Providence City Plan Commission

August 17, 2021

AGENDA ITEM 1 ■ 230 WATERMAN STREET

CASE NO./ PROJECT TYPE: 21-020 MA
Master Plan with dimensional adjustments for height and parking

Conceptual site plan and basement level parking

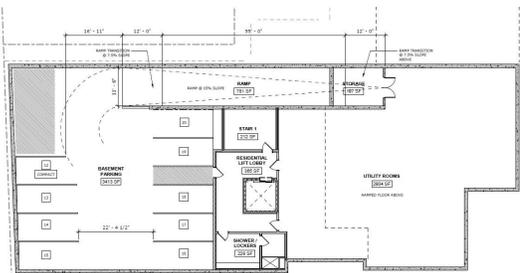
The applicant is proposing to provide twenty parking spaces with 11 located on the Waterman Street level and nine additional spaces provided in the basement level accessible from the Waterman Street parking area. The applicant is requesting an approximately 48 percent parking adjustment where 38 spaces are required and 20 will be provided.

Physical access to the site is provided from Wayland Ave and Waterman Street. As Waterman is a heavily travelled street, the applicant should evaluate the safety of vehicles entering and exiting the parking area and provide information about the impact that these vehicles will have on traffic circulation.

Project Section and South Elevation

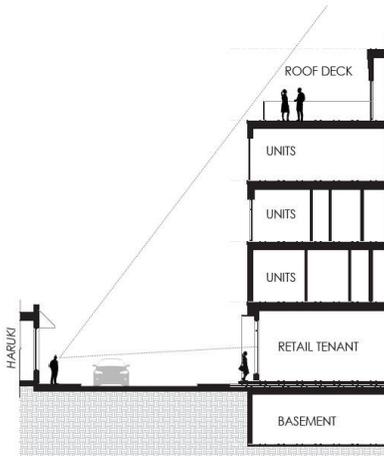
A height of approximately 64' and five stories is requested where the maximum allowable height is 50' and four stories. A 48 percent parking reduction—where 38 spaces are required and 20 will be provided—is requested. Per the Zoning Ordinance, Section 1904.E, the CPC may grant dimensional adjustments where vertical mixed-use development is provided of which at least 50 percent is devoted to residential use and/or if structured parking is provided. The development exceeds the amount of required residential use and internal structured parking is provided. The applicant has provided a height diagram which compares the building's height to neighboring property at 229 Waterman, which shows that the resultant height will be comparable to what currently exists, and is not expected to have a negative effect on neighborhood character. Bicycle infrastructure including shower and locker facilities, and access to public transport is available in proximity to the development, which reduces the reliance on parking. The DPD supports these adjustments because they are in accordance with the eligibility for dimensional adjustments.

Dimensions: As discussed, the building's design and layout conform to the regulations of the C-2 zone. Subject to the CPC granting the dimensional height adjustment for 14 feet and one story, the development conforms to the ordinance.

1. The CPC should grant the dimensional adjustments for 14' and one story of height and a 48 percent reduction in the amount of required parking, finding that the project will provide structured parking and mixed-use with at least 50 percent of the building devoted to residential use.
2. The CPC should approve the master plan subject to the following conditions:
 - A. The applicant shall evaluate the safety of vehicles entering and exiting the parking area and shall provide information about the impact that these vehicles will have on traffic circulation. These findings shall be provided at the preliminary plan stage.
 - B. A detailed landscaping plan shall be submitted at the preliminary plan stage.
 - C. The applicant shall obtain right-of-way encroachment permits for building overhangs prior to final plan approval.
